TITLE: TagV2p2_r4		REV: 3
嘉立创EDA	Company: Project CETI	Sheet: 1/9
	Date: 2023-05-12	Drawn By: Shreya Singh

CHANGE LOG

NOTES, ISSUES AND TODO LIST

BMS

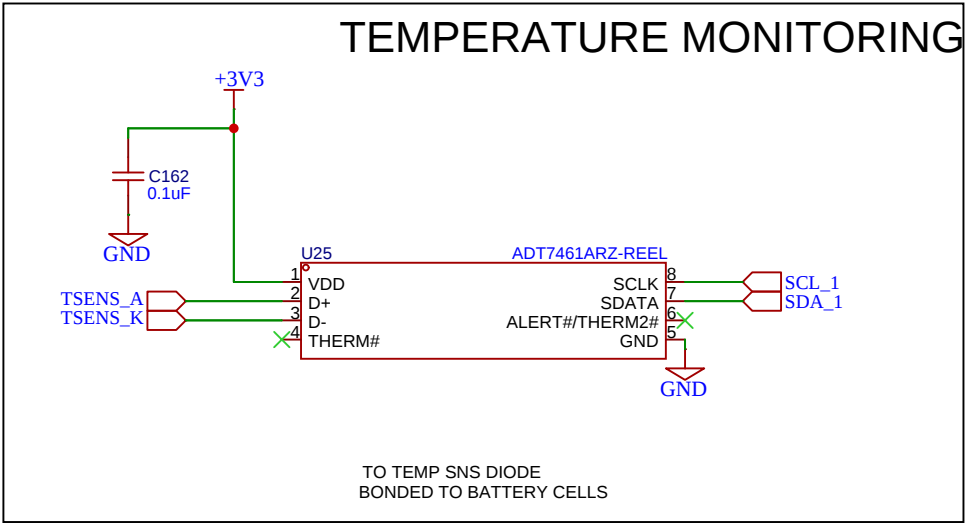
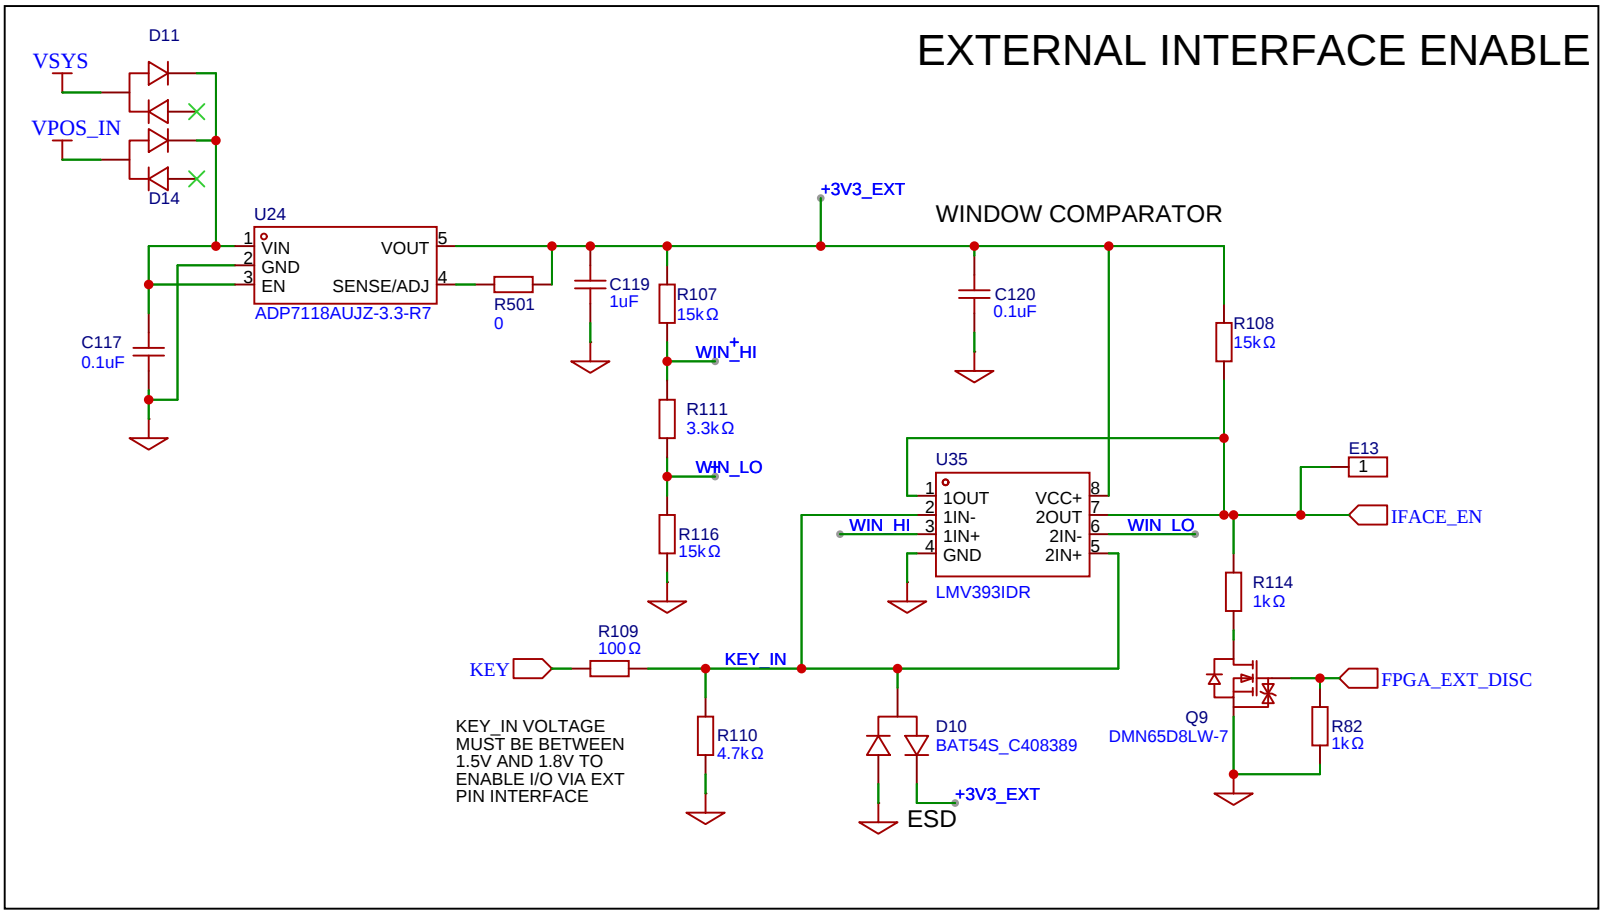
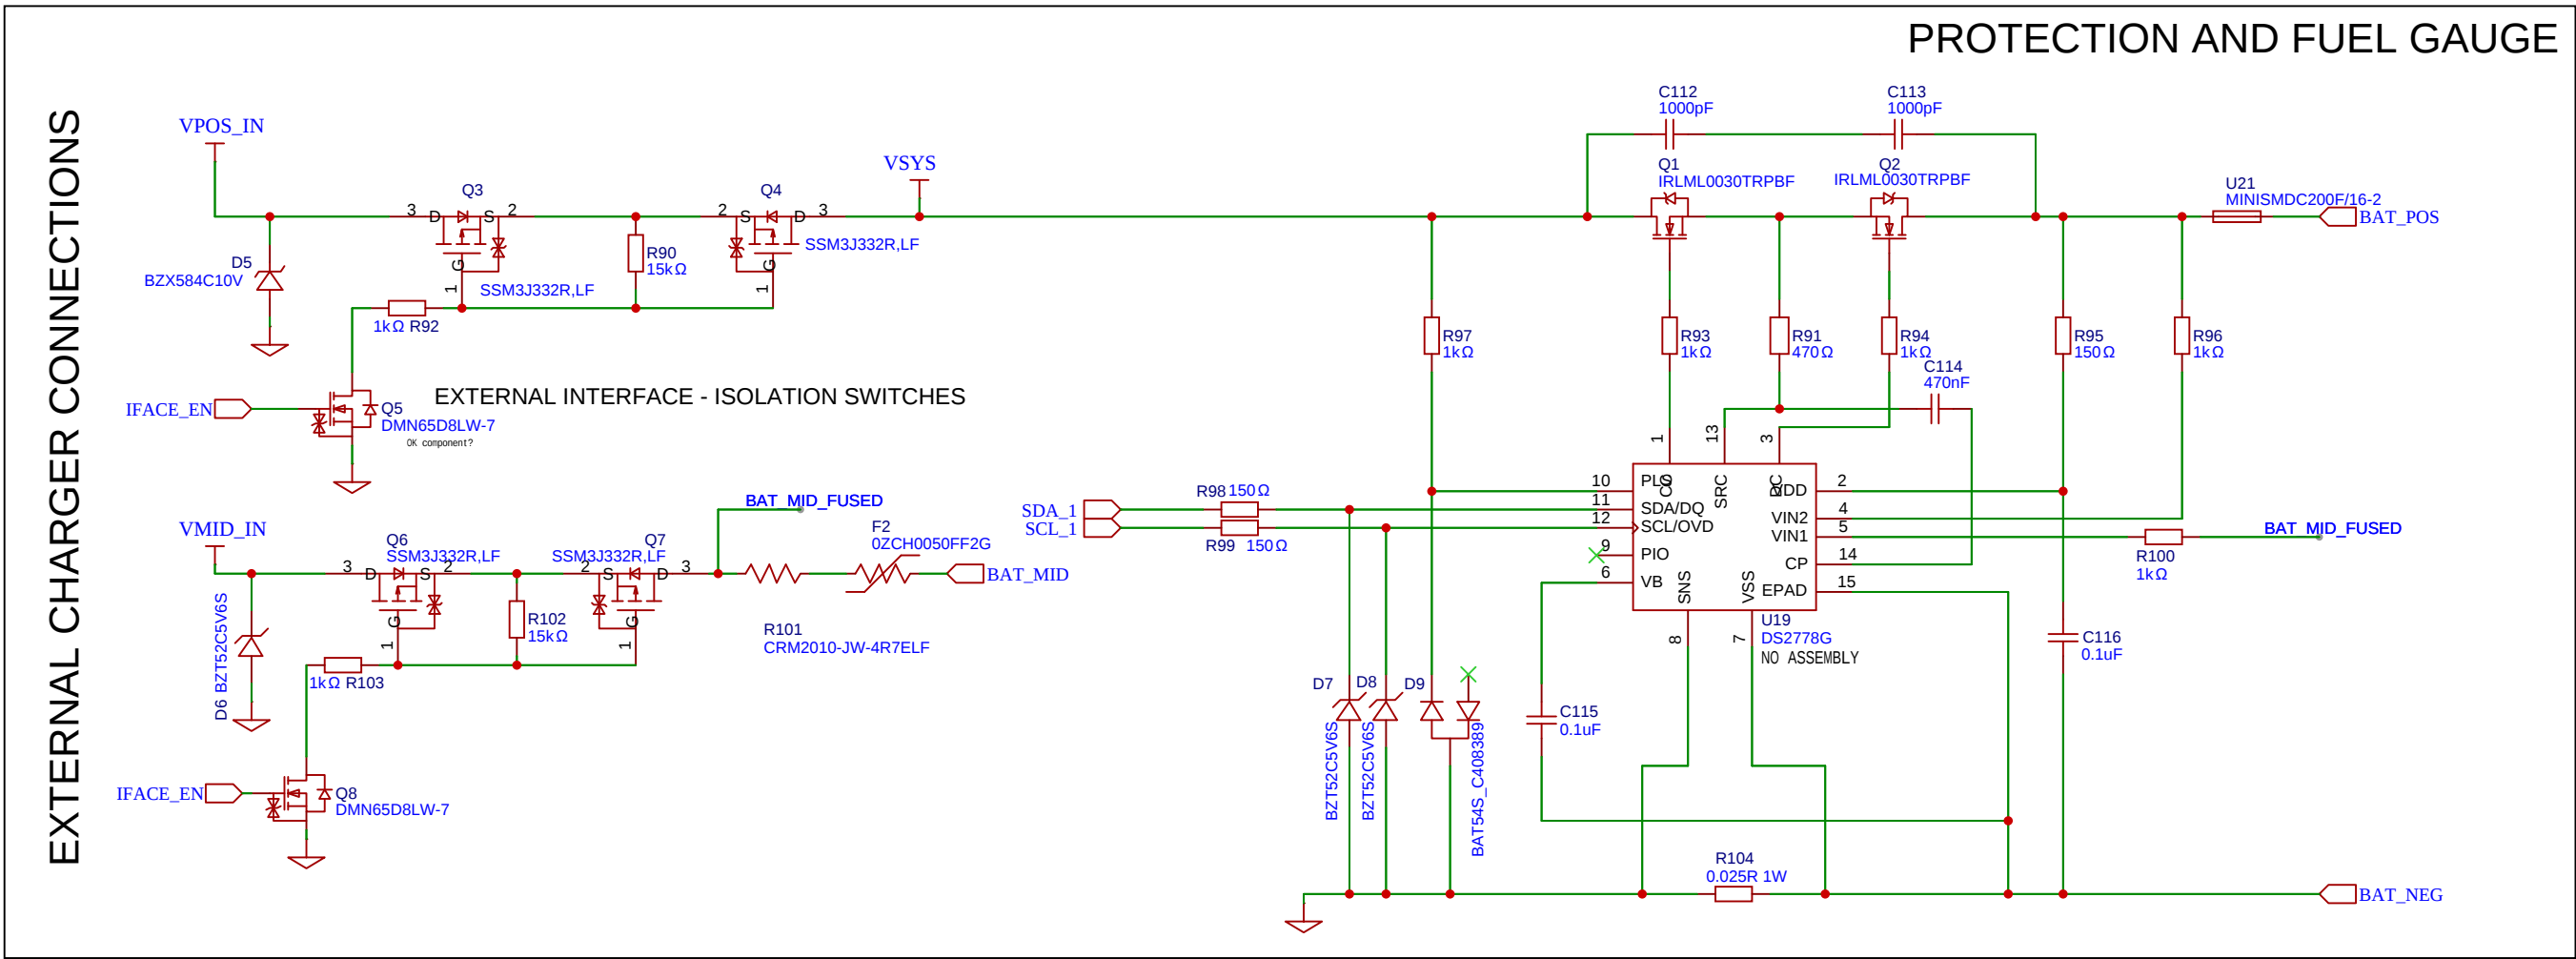
DRAW OP AMPS AND COMPARATORS AS FUNCTIONAL SYMBOLS NOT BOX SYMBOLS
ADC SYMBOL IS DRAWN AS THE 8-CH INCORRECT PIN LABELS FOR 4-CH
CETI/SEAS LOGO ON TEMPLATE
FIX BMS IC SO PIN NAMES ARE LEGIBLE
